Z-33 (2015)

CURRENT ZONING:
R-15 & GC
PROPOSED ZONING:
CRC

CAS-HILL, LLC
LAND LOT 709
16th DISTRICT 2nd SECTION
COBB COUNTY, GEORGIA

PETITION NO: Z-33

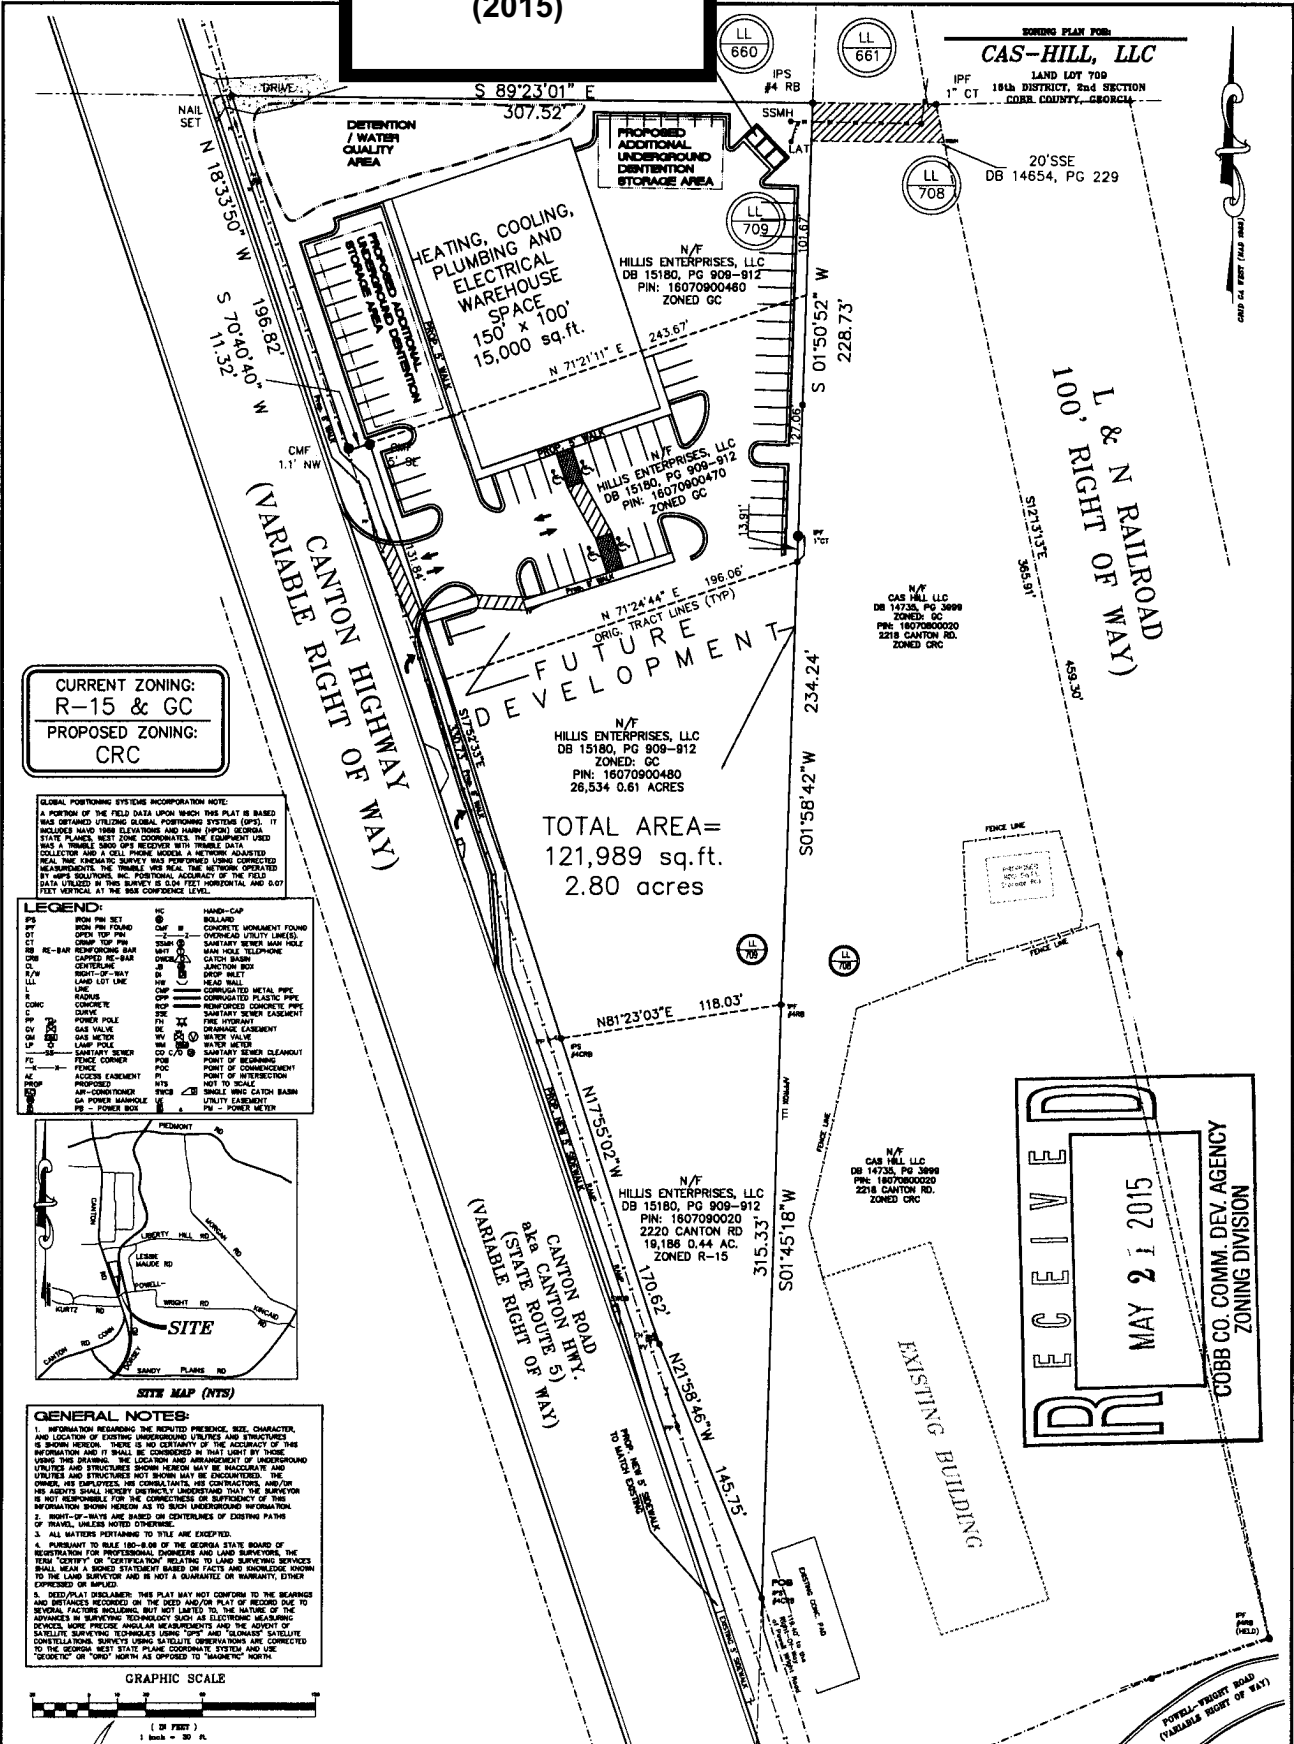
- No Stormwater controls shown _____
- Copy of survey is not current – Additional comments may be forthcoming when current site conditions are exposed.
- No site improvements showing on exhibit.

1. The site is located to the east of Canton Road. The entire site drains to the existing railroad right-of-way to the east.
2. Although not indicated on the site plan, either a master stormwater management facility that would accommodate all future improvements to both tracts or two separate facilities (one for each tract) will be required.
